ADDENDUM 4

PROJECT NAME: Frank Garrett HVAC Project

ADDENDUM #3

Date: 11/27/2023
Client: MARMON MOK ARCHITECTURE
Project Name: FRANK GARRETT COMMUNITY CENTER RENOVATION-PACKAGE 2
Project Number: 23002

SHEET NO.
M101

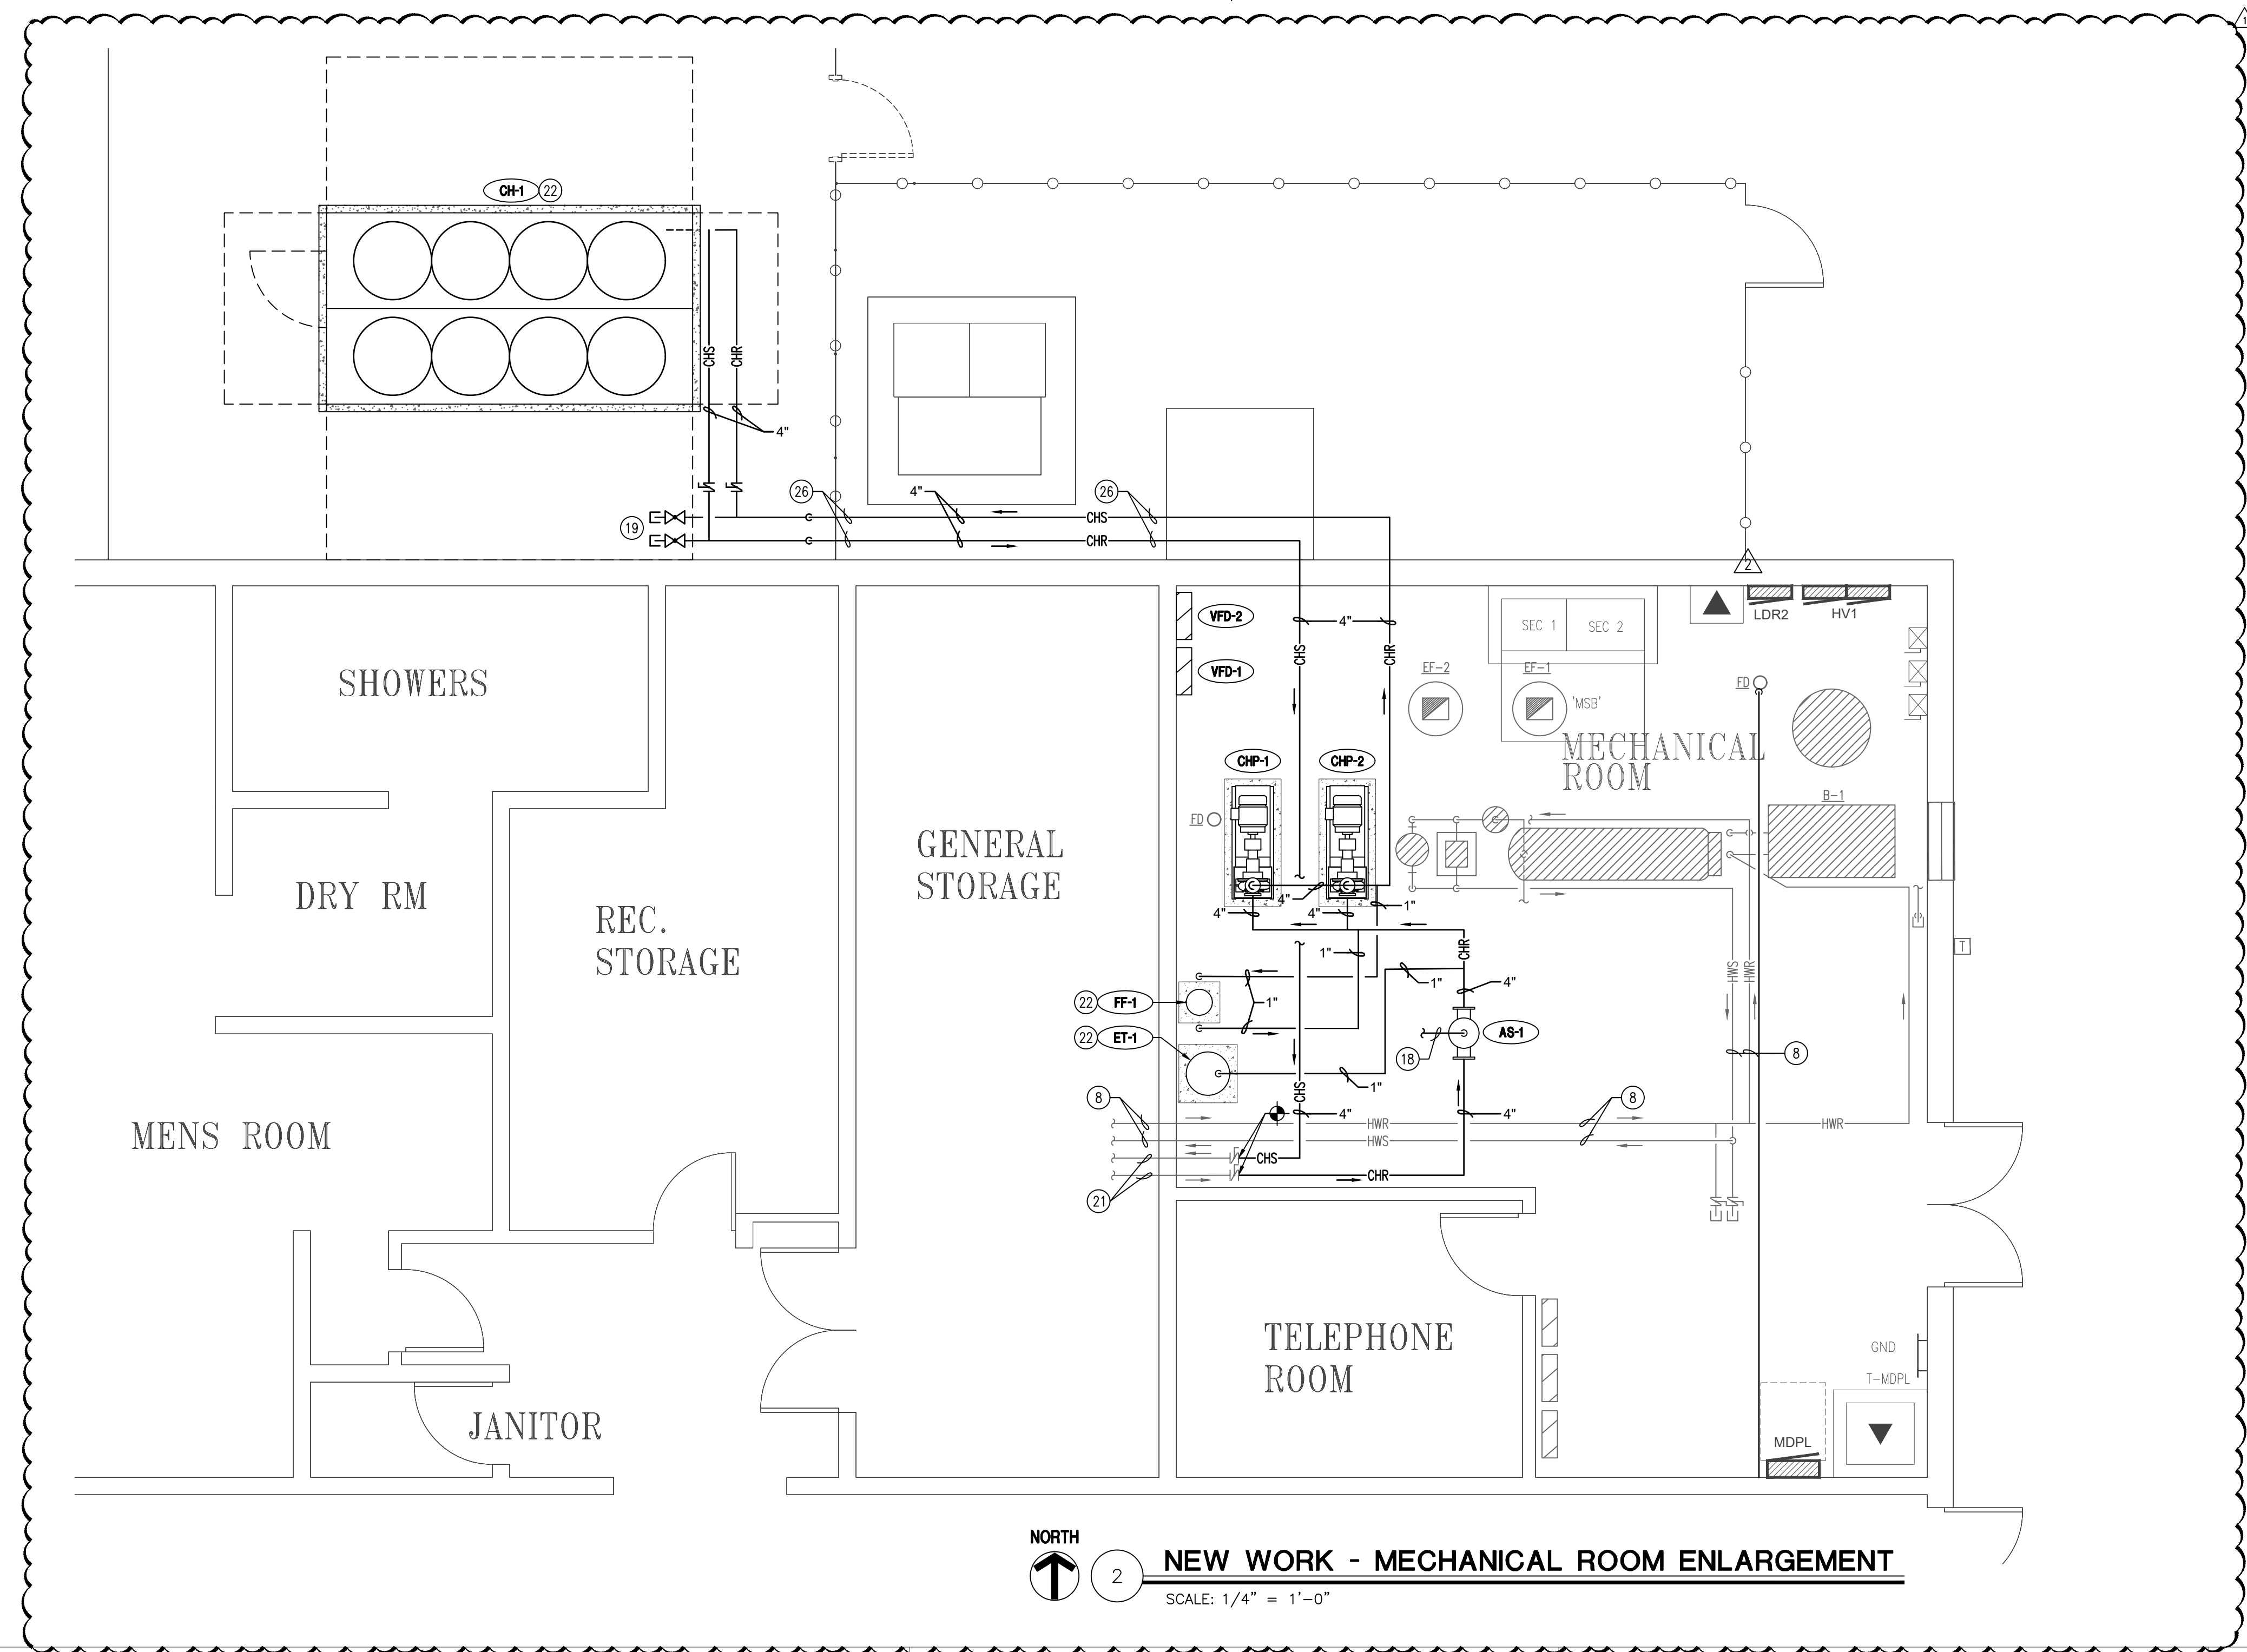
Question #7: What are the pipe sizes to all new chilled water piping? Not shown on drawings.

RE: Plan Sheet M101:

Item 1: Updated piping sizes.

Answer: See Addendum #3 drawings for pipe sizes.

SHEET NO.
P101

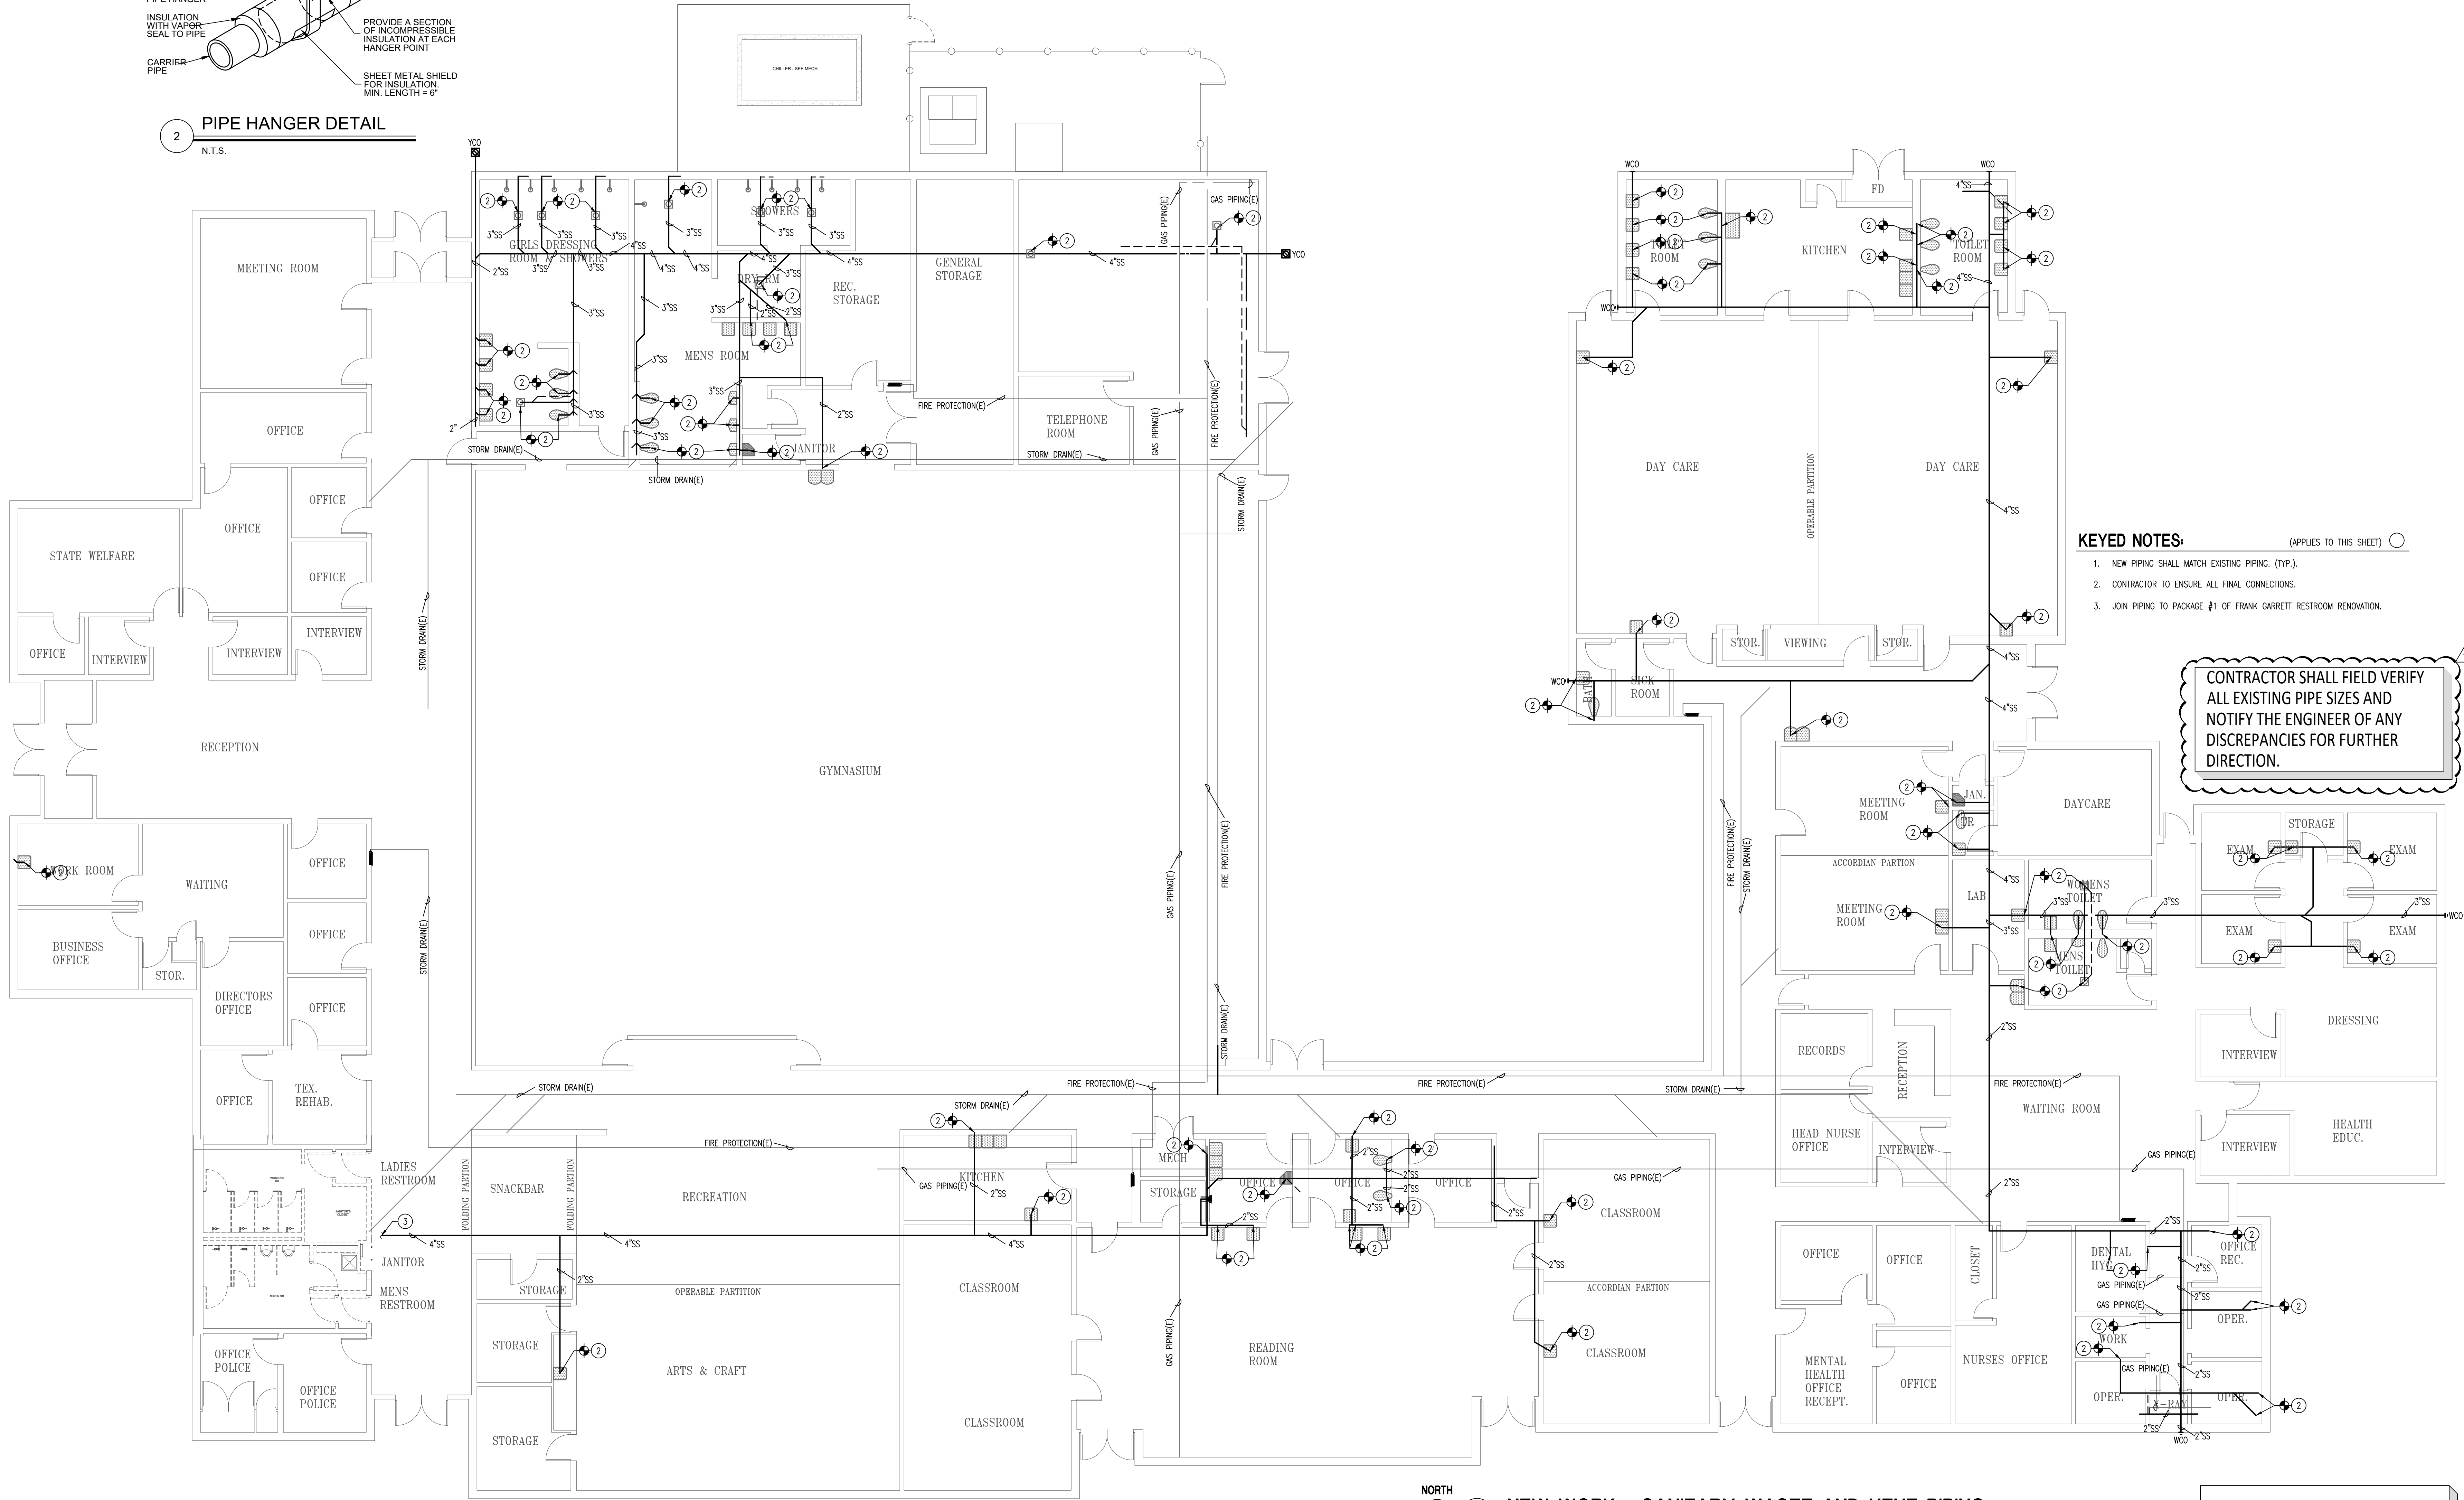
RE: Plan Sheet P101:

Item 1: Added block note.

SHEET NO.
P102

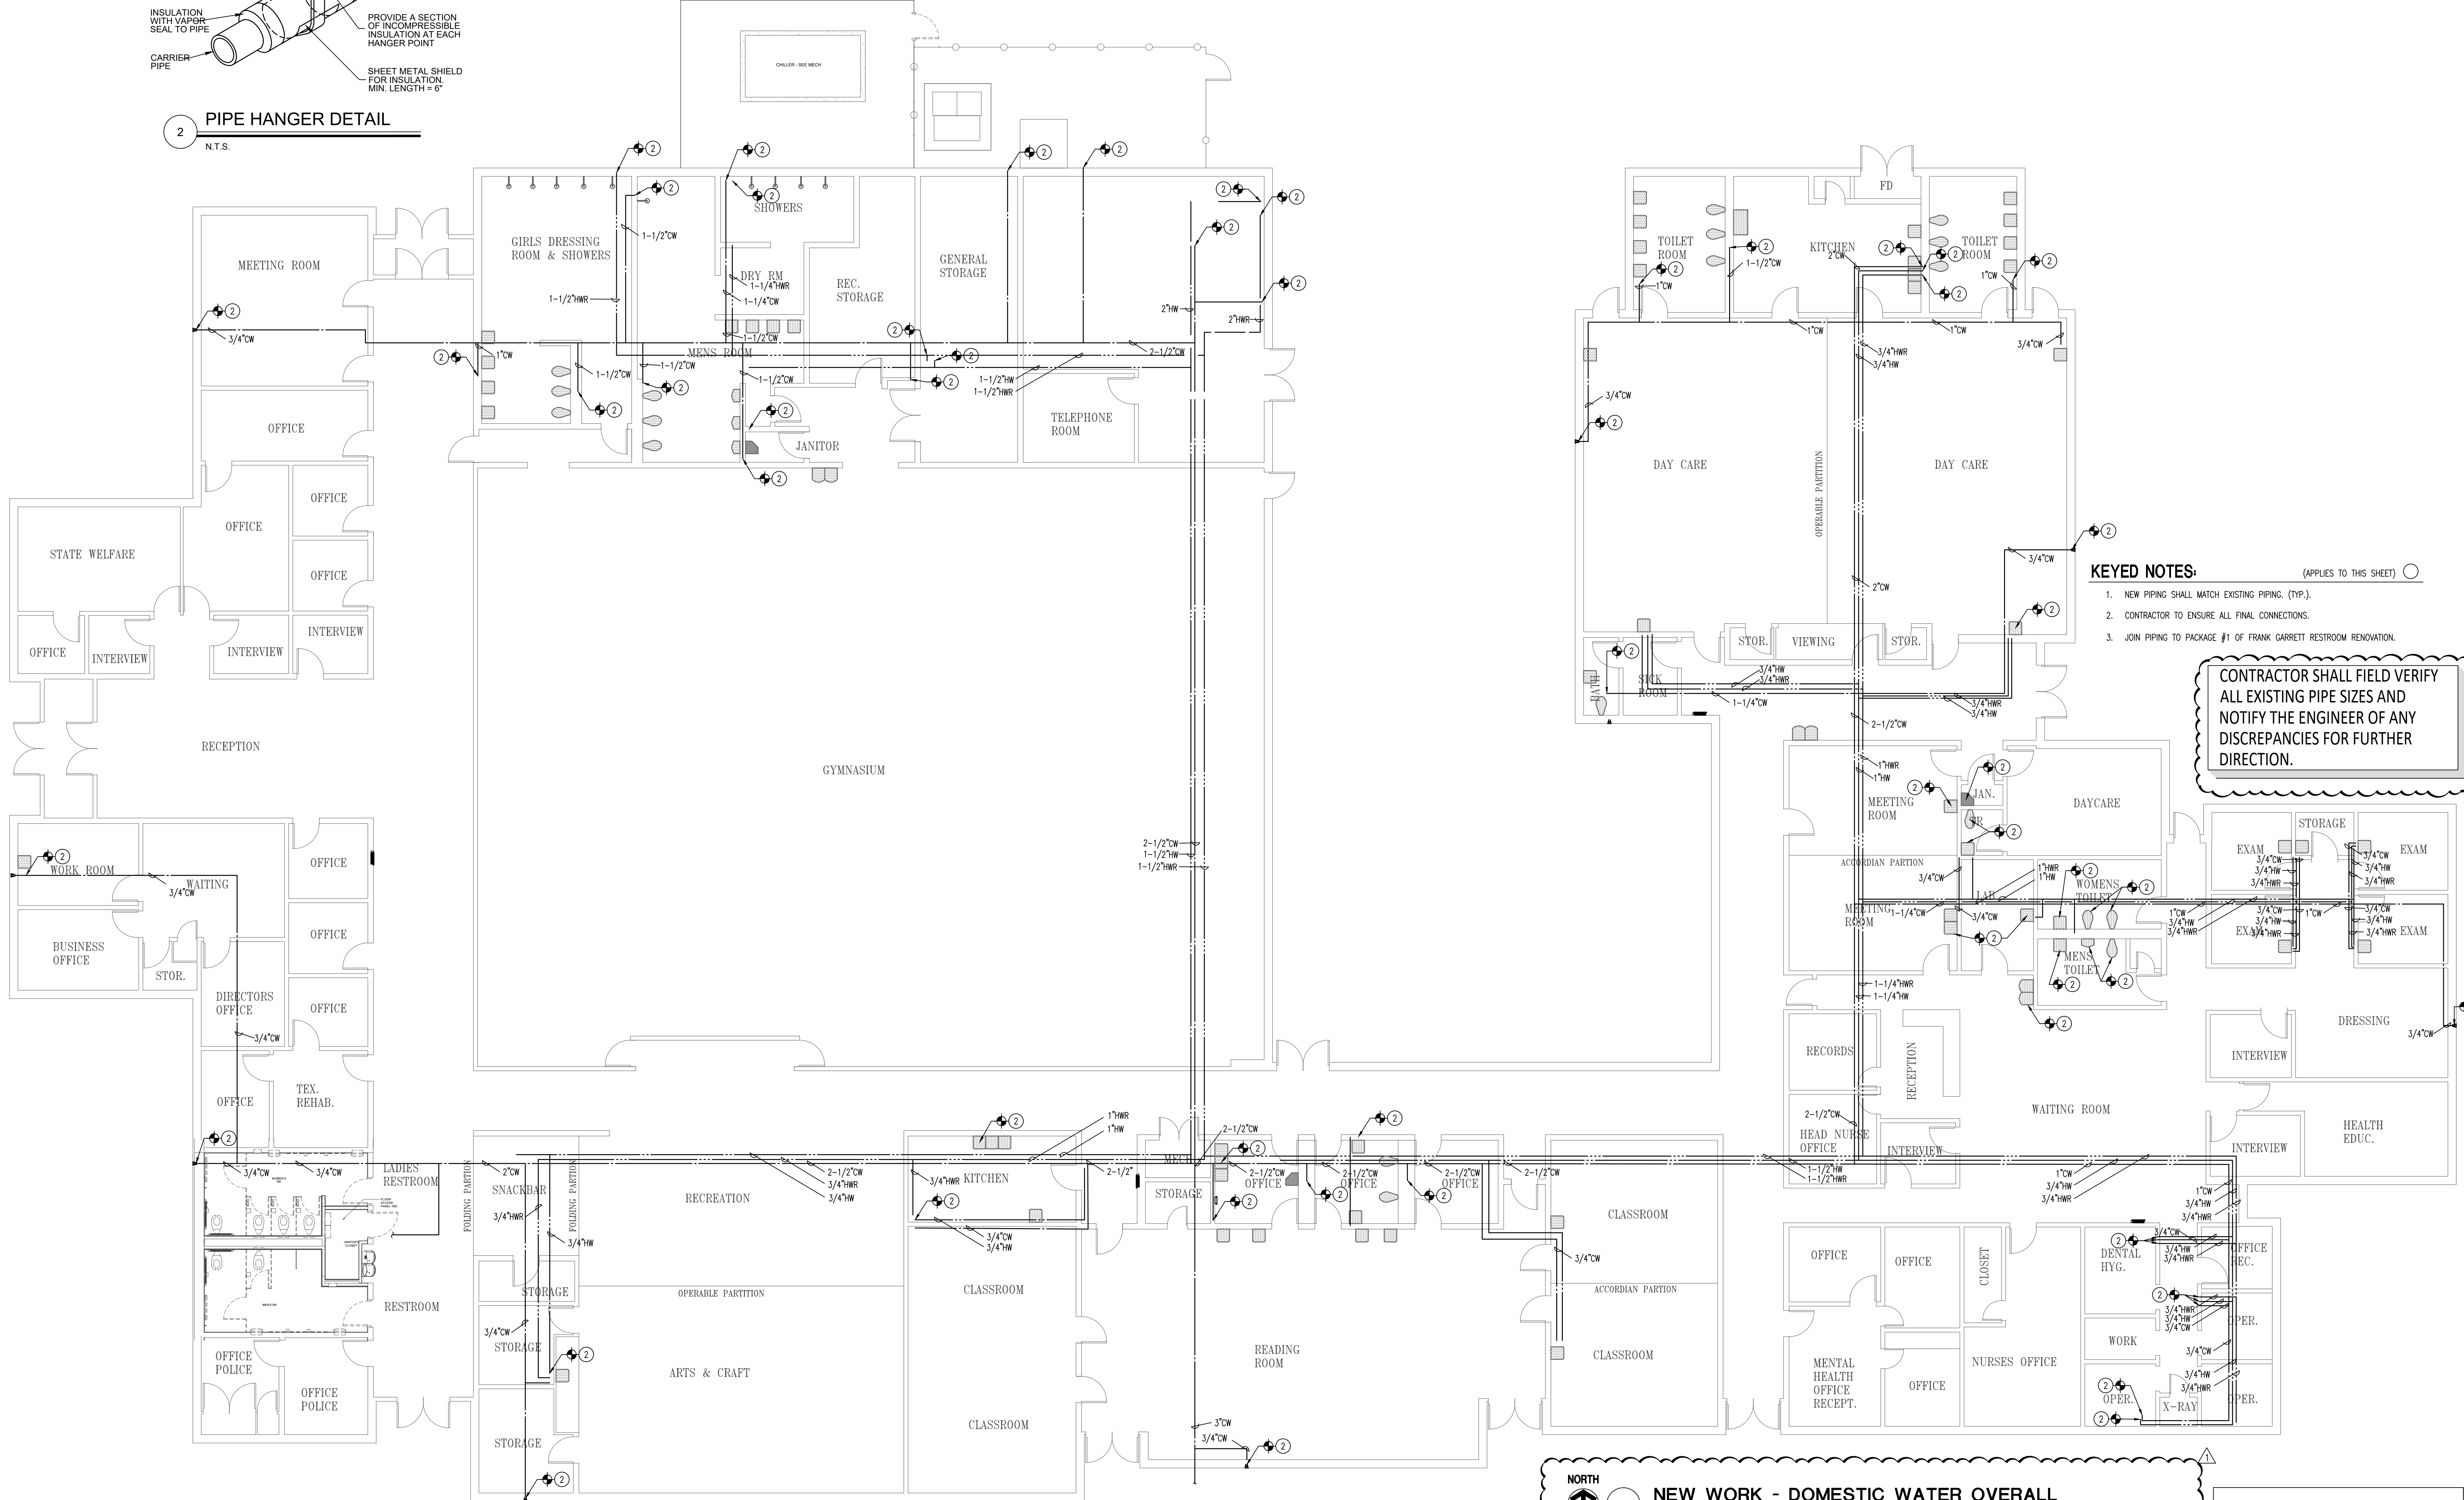
Question #6: Pipe sizes for the domestic cold water and sanitary sewer are the only pipe sizes shown. Pipe sizes for the domestic hot water and hot water return are not shown. In order to price these systems, all pipe sizes will be required, and site visit is not enough time for us to do this.

RE: Plan Sheet -P102:

Item 1: Added block note.

Item 2: Updated piping sizes.

Answer: See Addendum #3 drawings for pipe sizes.
